MACQUARIE RIVER TO ORANGE PIPELINE PROJECT

Independent Review of Hydrological Modelling

Final Report

8 April 2013

Revised Figure 25 from Appendix D of EA (with coloured annotations by reviewer)

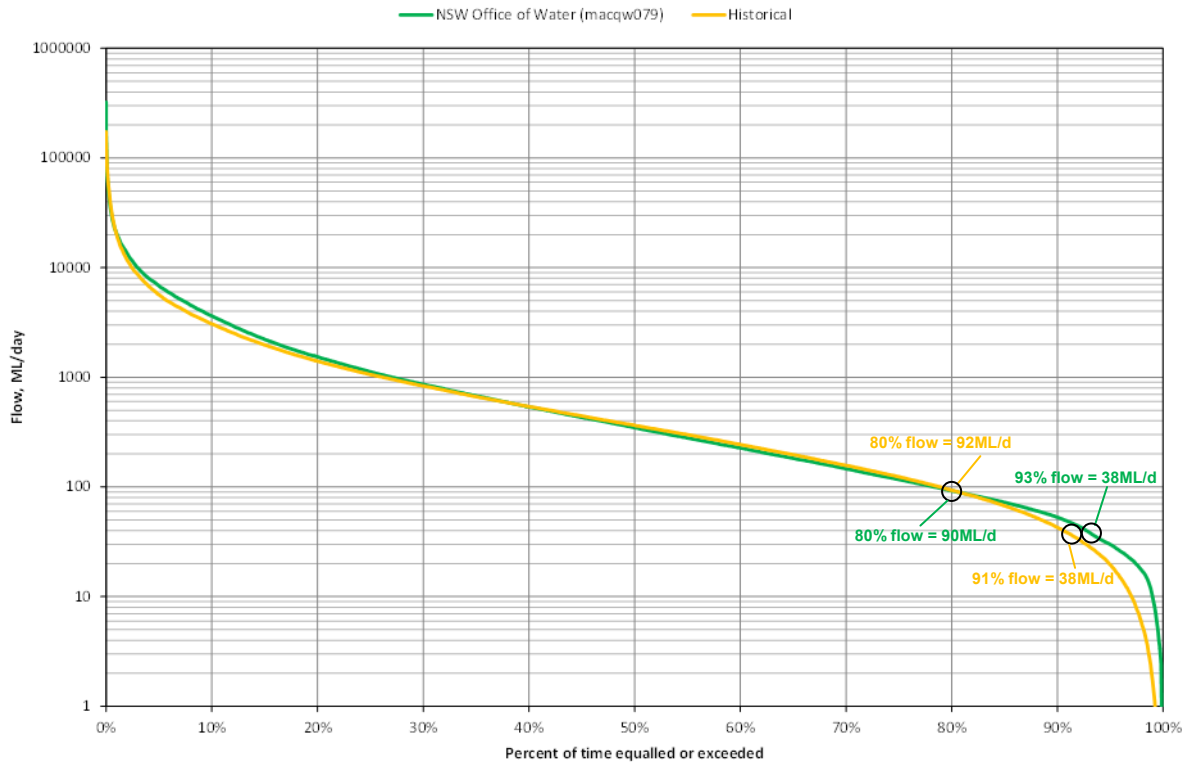
The flow frequencies at the pump site have been discussed in a number of places within the EA and the PPR. Note that there were some typographical errors in Figures 25 and 26 of Appendix D of the EA and these figures have since been revised by Geolyse and amended figures reproduced in **Appendix C**.¹⁹

On 15 March 2013 the reviewer obtained a copy of the river flows simulated by NOW using IQQM for current conditions assuming implementation of the relevant water sharing plans.²¹ This data was analysed by the reviewer and the following statistics were obtained, some of which are very similar to the information presented by Geolyse for NOW's "macqw079" data set that is reproduced in **Appendix C**:

- (a) 97th percentile flow = 22ML/d;
- (b) 95th percentile flow = 30ML/d;
- (c) 93rd percentile flow = 38ML/d;
- (d) 80th percentile flow = 92ML/d; and
- (e) 77th percentile flow = 108ML/d.

²¹ This is the "macqw120_dixons" data set. The IQQM used for this run is understood to be very similar to the IQQM model that was separately reviewed and has been described in Footnote 20. It also appears similar to the "macqw079" model run reported in the EA and shown in the revised Figure 25 in **Appendix C**.
